TVA-SQN-TS-05-03

SEQUOYAH NUCLEAR PLANT (SQN) - UNITS 1 AND 2 - TECHNICAL SPECIFICATIONS (TS) CHANGE 05-03 "REVISION OF ACTIONS AND APPLICABILITY FOR REACTOR TRIP SYSTEM INSTRUMENTATION, TURBINE TRIP"

TENNESSEE VALLEY AUTHORITY (TVA) SEQUOYAH NUCLEAR PLANT (SQN) UNITS 1 AND 2

Proposed Technical Specification Changes (mark-up)

3/4 3-3

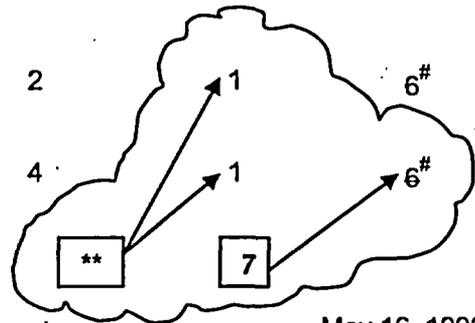
17. Underfrequency-Reactor Coolant Pumps	4-1/bus	2	3	1	6 [#]
18. Turbine Trip					
A. Low Fluid Oil Pressure	3	2	2		
B. Turbine Stop Valve Closure	4	4	4

ACTION 7 - Deleted
Insert 1

ACTION 7 - With the number of OPERABLE channels one less than the Total Number of Channels, STARTUP and/or POWER OPERATION may proceed provided the inoperable channel is placed in the tripped condition within 6 hours or THERMAL POWER is reduced to less than P-9 within 10 hours.

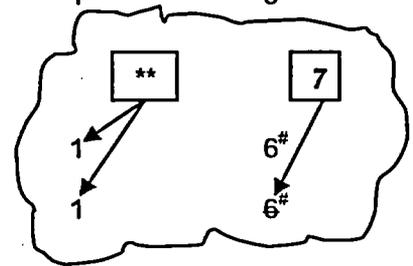
<u>FUNCTIONAL UNIT</u>	<u>TOTAL NO. OF CHANNELS</u>	<u>CHANNELS TO TRIP</u>	<u>MINIMUM CHANNELS OPERABLE</u>	<u>APPLICABLE MODES</u>	<u>ACTION</u>
16. Undervoltage-Reactor Coolant Pumps	4-1/bus	2	3	1	6 [#]
17. Underfrequency-Reactor Coolant Pumps	4-1/bus	2	3	1	6 [#]
18. Turbine Trip					
A. Low Fluid Oil Pressure	3	2	2		
B. Turbine Stop Valve Closure	4	4	4		
19. Safety Injection Input from ESF	2	1	2	1, 2	12
20. Reactor Trip Breakers					
A. Startup and Power Operation	2	1	2	1, 2	12, 15
B. Shutdown	2	1	2	3*, 4* and 5*	16
21. Automatic Trip Logic					
A. Startup and Power Operation	2	1	2	1, 2	12
B. Shutdown	2	1	2	3*, 4* and 5*	16
22. Reactor Trip System Interlocks					
A. Intermediate Range Neutron Flux, P-6	2	1	2	2, and*	8a
B. Power Range Neutron Flux, P-7	4	2	3	1	8b

ACTION 7 - Deleted.

Insert 1
